THM 4T60-E NEW DESIGN HEAVY DUTY FINAL DRIVE ASSEMBLY, FOR SUPERCHARGED MODELS

Figure 1

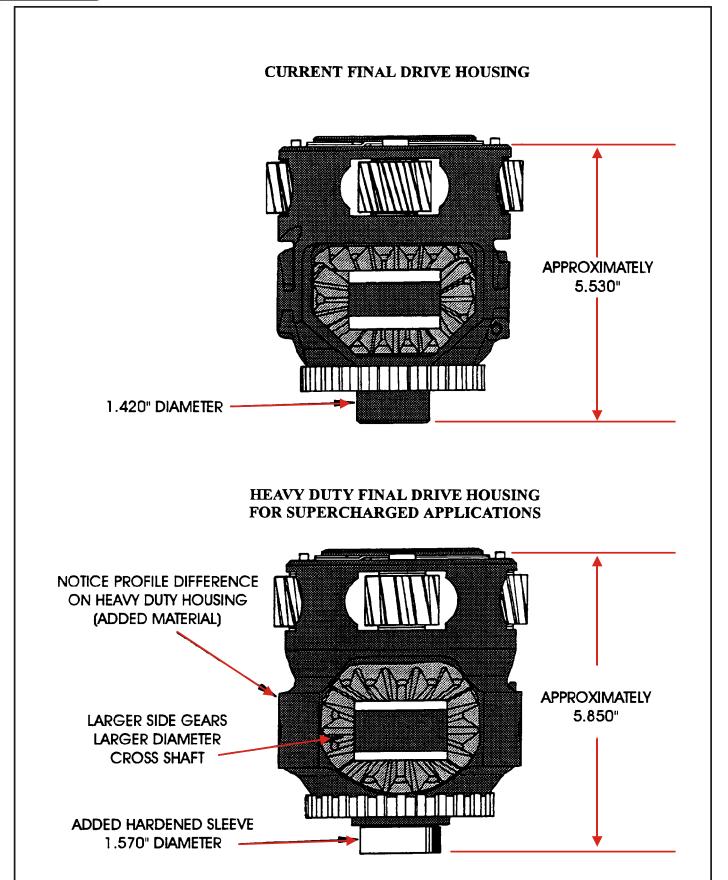
- (1) FINAL DRIVE ASSEMBLY The final drive housing has added material in the cross shaft area, is longer than the previous model, has larger side gears and pinion gears, has a larger diameter cross shaft, and a hardened sleeve added that rides in a new torrington bearing in the final drive housing. Refer to Figure 1 for comparisons between the previous and new design.

Figure 2

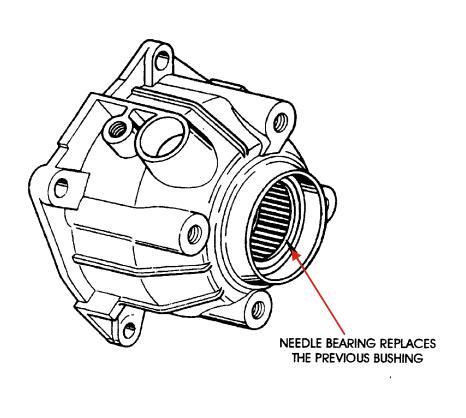
- (2) **FINAL DRIVE HOUSING** Now a different dimension to accommodate the new design final drive assembly and has an added needle bearing that replaces the previous design bushing, and is shown in Figure 2.
